COMMUNITY
connectivity program

Seymour

Town Center

– Road Safety Audit

Figure 15 - River Street Sidewalk

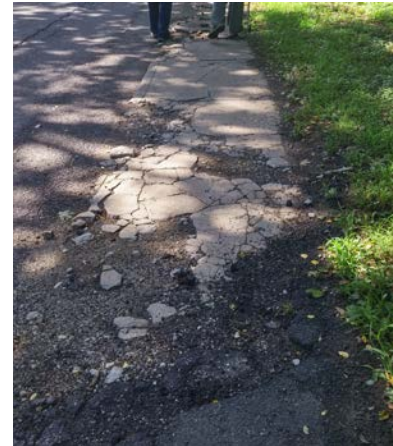
- River Street has a short section of sidewalk on the east side, but it disappears south of the River Street Bridge (Figure 15). The sidewalk on the west side is in very poor condition. It is concrete, and sometimes has an asphalt overlay, but is broken in multiple locations. The curb reveal has been reduced to near zero.

7. Where practical, reconstruct sidewalks to a minimum standard of 5 feet wide. River Street is a priority on the west side to provide connectivity between the parks. Use consistent materials throughout the downtown area.
